## **REMARKS**

Claims 1-54 were originally pending in the application. Claims 24-54 have been withdrawn without prejudice. Claims 1-23 are rejected, and claim 24 is objected to. Claims 1, 10, 22, and 23 have been amended. New claims 55-106 have been added. Claims 1-23 and 55-106 are now pending. Favorable reconsideration and allowance of this application is respectfully requested in light of the claim amendments and the following remarks.

FIG. 2A

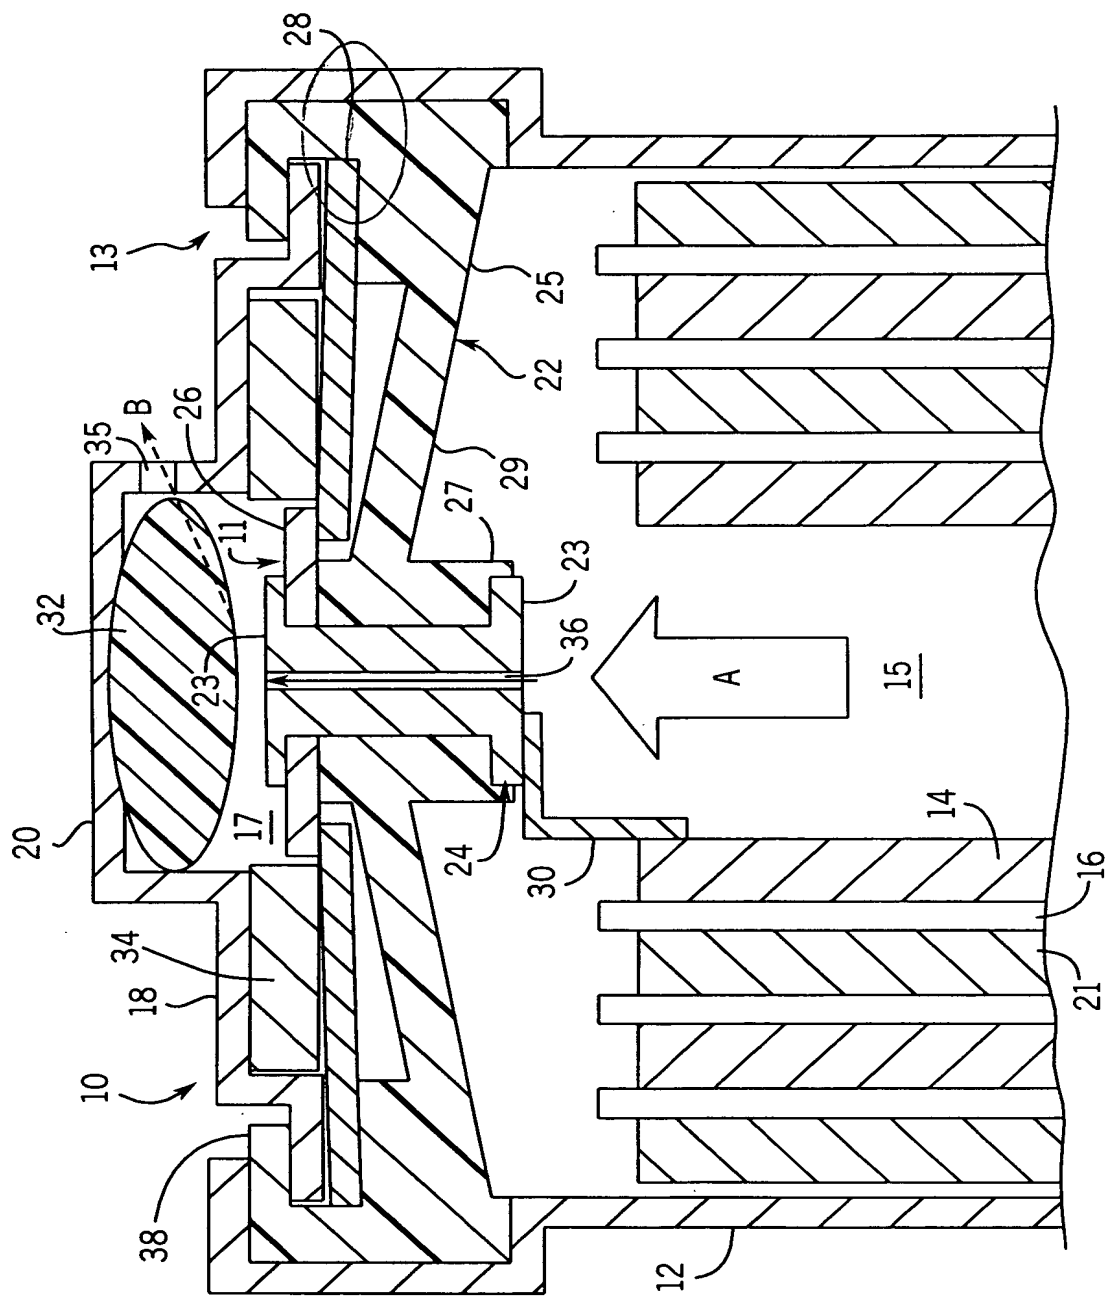
The drawings were objected to because the lead line from reference sign "28" in Fig. 2A leads to a different structure than that in Fig. 2B. Fig. 2A has been revised to properly identify the annular contact by reference numeral "28" in a manner consistent with Fig. 2B.

An annotated marked-up Fig. 2A is enclosed with the change identified in red ink. A Formal Sheet 2 bearing Fig. 2A incorporating the above drawing change is also enclosed for approval by the Examiner.

An annotated marked-up Fig. 2A is enclosed showing changes to reference numeral “28” in red ink.
